## LuK Service Info

# Part Nr: 231 0043 10 — 305/305mm TGU6

Info: New design/Neues Design/Nouvelle conception/Nuevo diseño/Nuovo disegno

231 0043 10 replaces/ersetzt/  
remplace/sustituye a/sostituisce  
231 0043 40

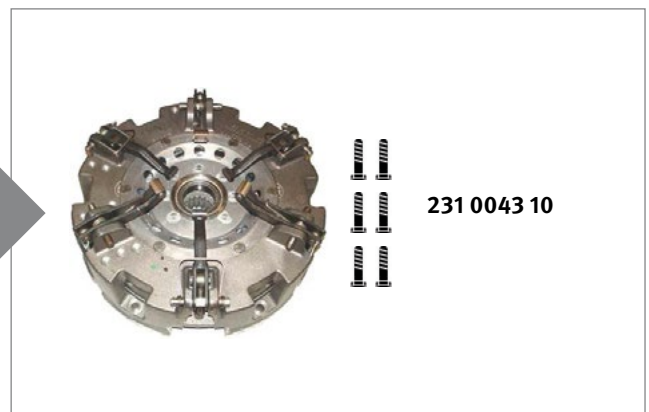
Bolts 3/8"UNC x 2" are supplied to fit new LuK clutch 231 0043 10.
